BUILDING 'C' AND BUILDING 'D' ELECTRICAL DEMOLITION PLAN

ADDENDUM #01
 RUTH HARDING SCHOOL
 MODERNIZATION
 BAKERSFIELD, KERN COUNTY, CALIFORNIA

**RUTH HARDING SCHOOL
 MODERNIZATION
 3201 PICO ST.
 FOR
 BAKERSFIELD CITY SCHOOL DISTRICT
 BAKERSFIELD, KERN COUNTY, CALIFORNIA**

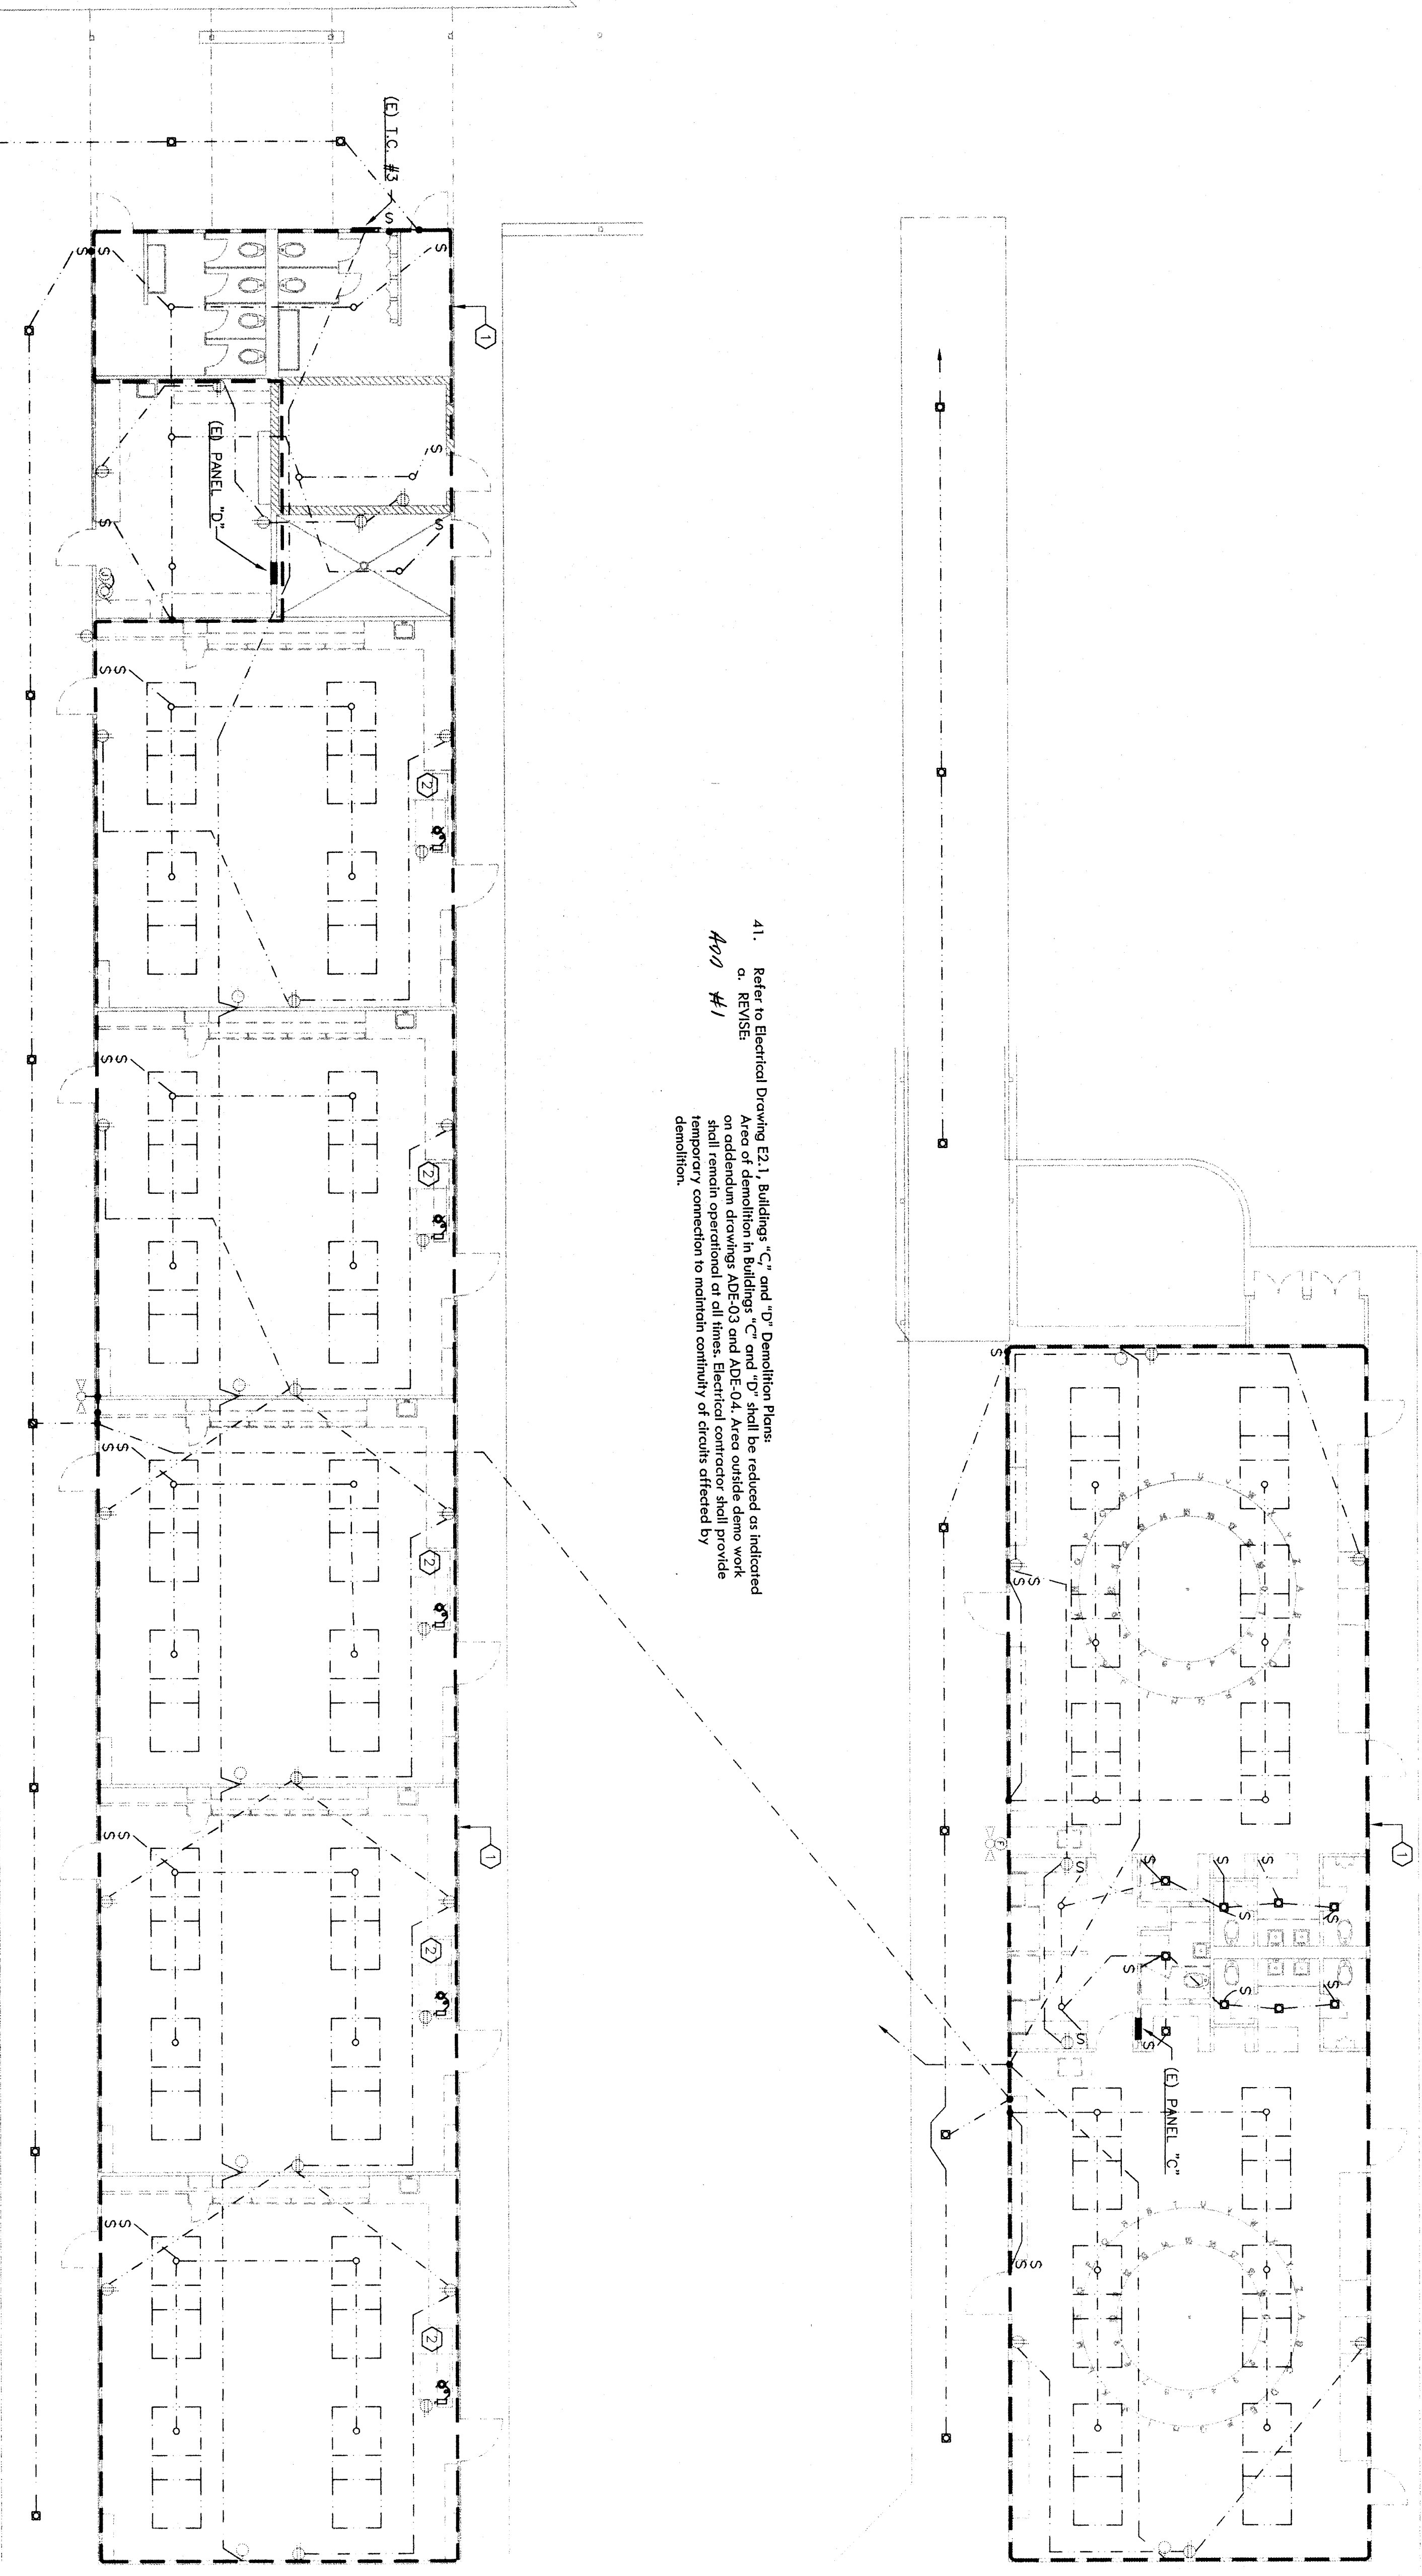
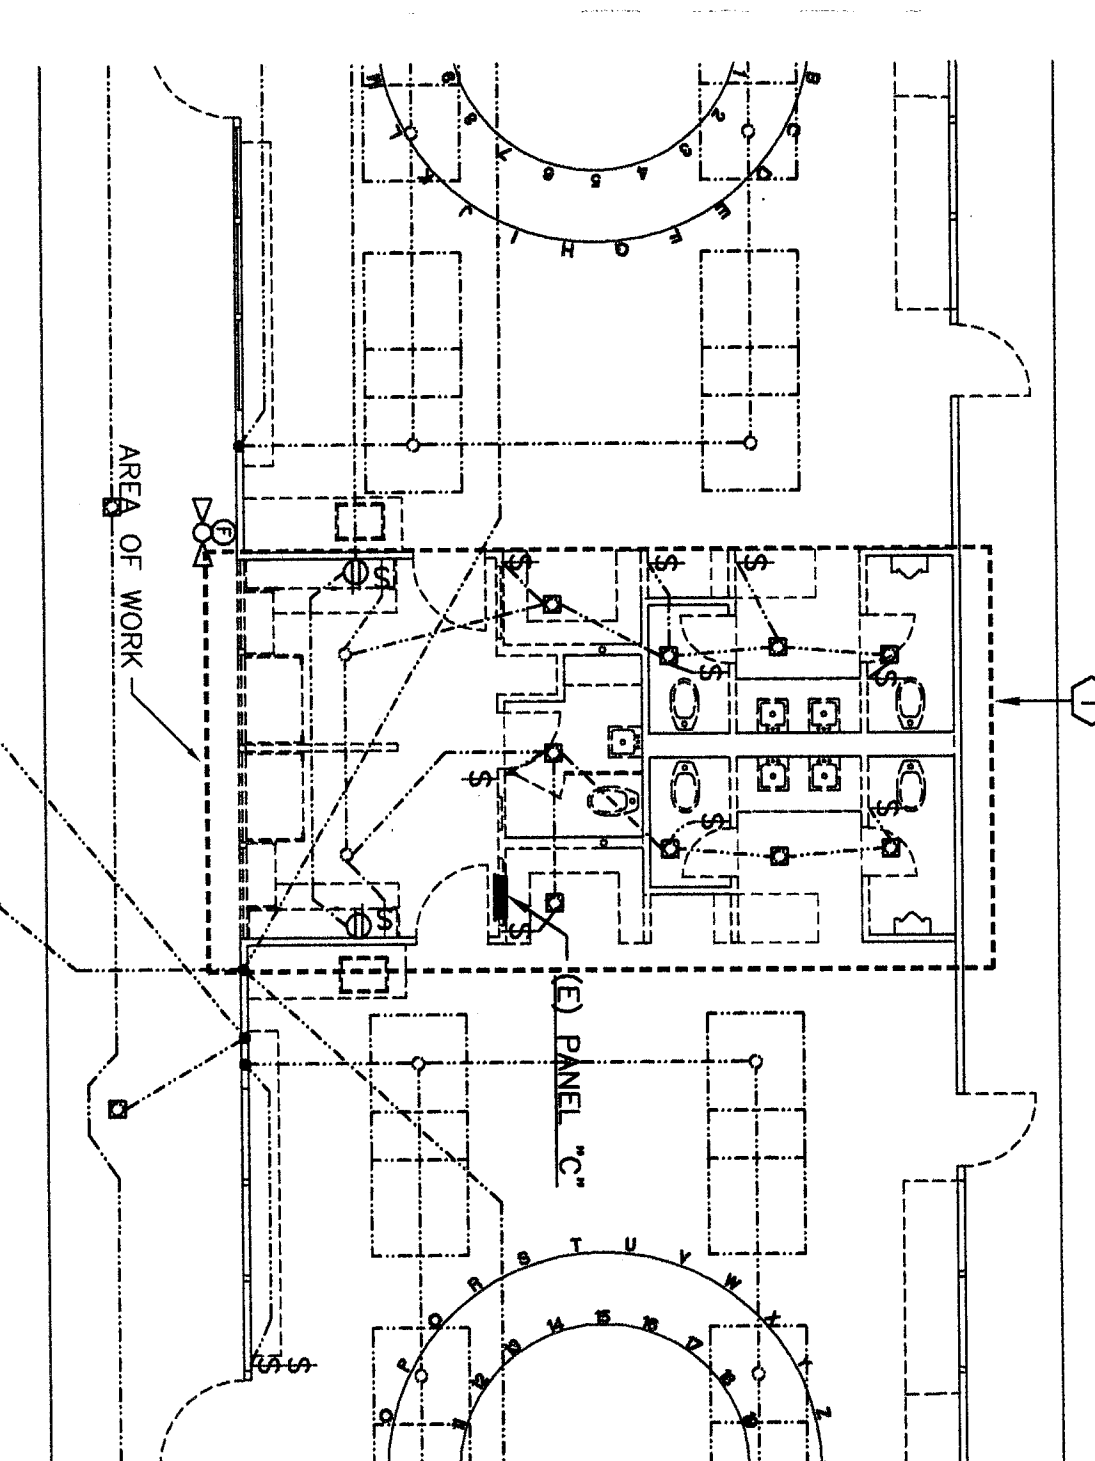
41. Refer to Electrical Drawing E-2.1, Buildings 'C' and 'D' Demolition Plan.
 a. REVISE
 Area of demo drawing ADE-03 and ADE-04. Area outside demo work shall remain operational at all times. Electrical contractor shall provide temporary connection to maintain continuity of circuits affected by demolition.
